AMENDED

SUNDRY NOTICES AND REPORTS ON WELLS

14. PERMIT NO.
15. ELEVATIONS (Show whether DF, ST, GR, etc.)
3634' DF
5. LEASE DESIGNATION AND SERIAL NO.
LC-028731 (B)
6. IF INDIAN, ALLOTTEE OR TRIBE NAME
7. UNIT AGREEMENT NAME
8. FARM OR LEASE NAME
M. Dodd "B"
9. WELL NO.
1
10. FIELD AND POOL, OR WILDCAT
Grbg Jackson SR Q G SA
11. SEC., T., R., M., OR BLK. AND SURVEY OR AREA
Sec. 14-T17S-R29E
12. COUNTY OR PARISH
Eddy
13. STATE
N.M.

SKETCH OF PROPOSED WELL PAD
 AND EXISTING WELL PAD
 Marbob Energy Corporation
 Well #2, M. Dodd "B" Federal

SUP Exhibit "D"

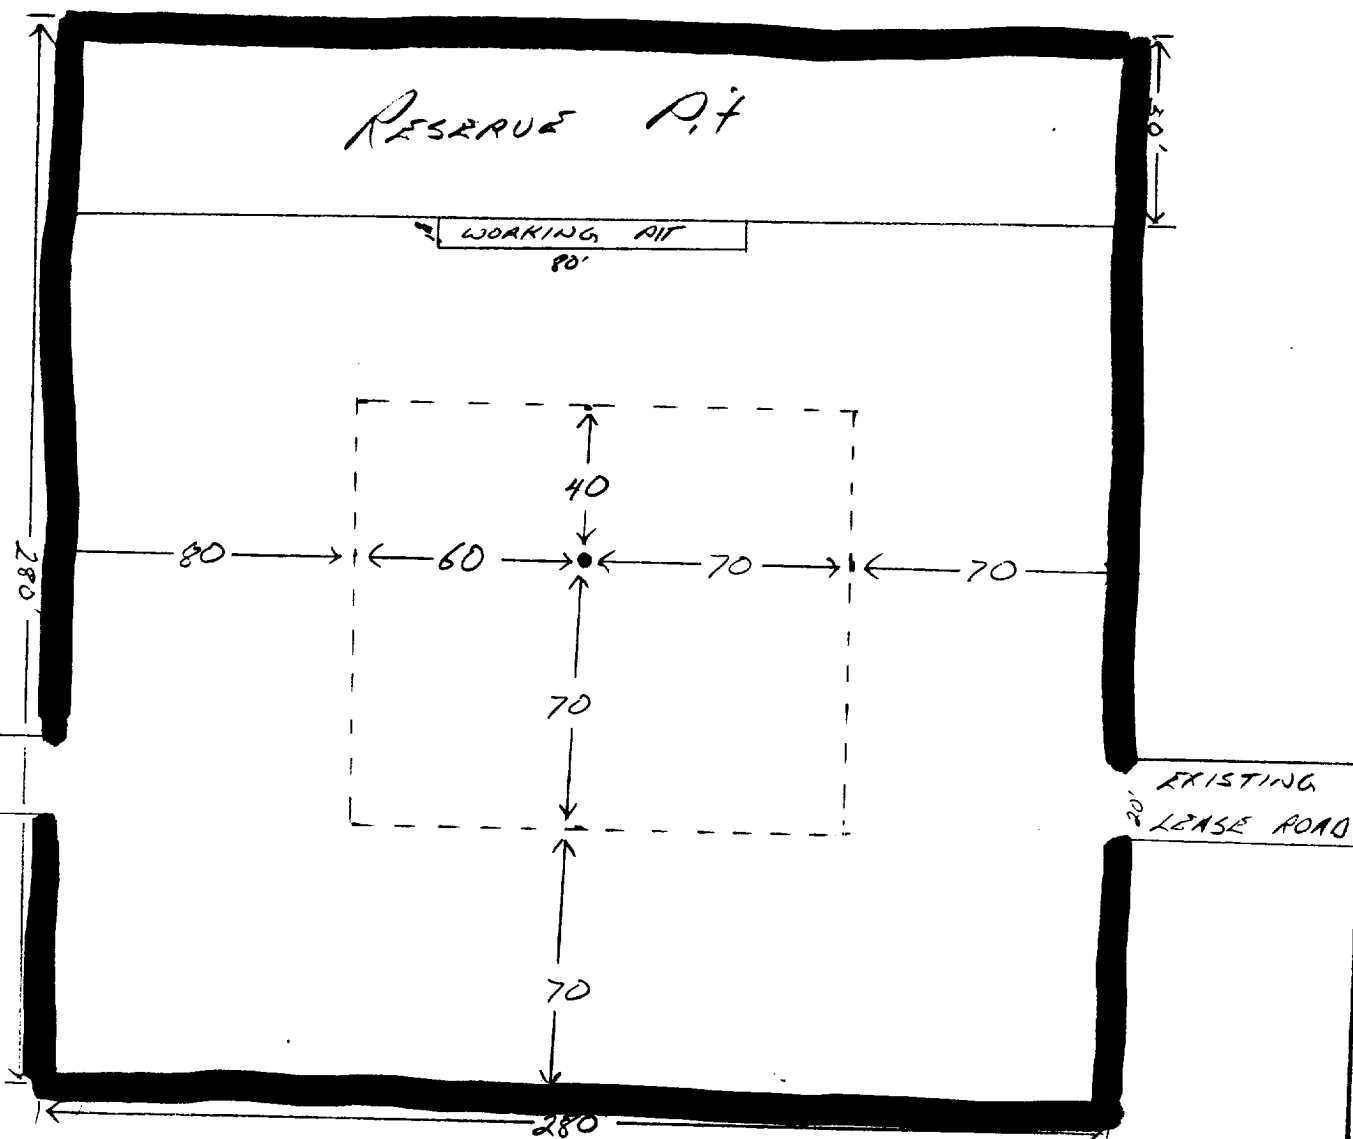
We propose to deepen this well from its present depth of 2550' to 4500'. w/Larue Drilling Rig #2. 7" pipe was run to 2284'. A 6 1/2" hole will be drilled. We will run temperature survey to find top of cement; squeeze to base of salt; perforate at top of salt; squeeze cement inside surface pipe or to surface; drill to 4500' and run 4 1/2" 11.60# J-55 new casing to TD and cement. The existing well pad will be extended to 280' x 280' as shown on the attached exhibit.

This will amend our sundry notice dated 4/23/85.
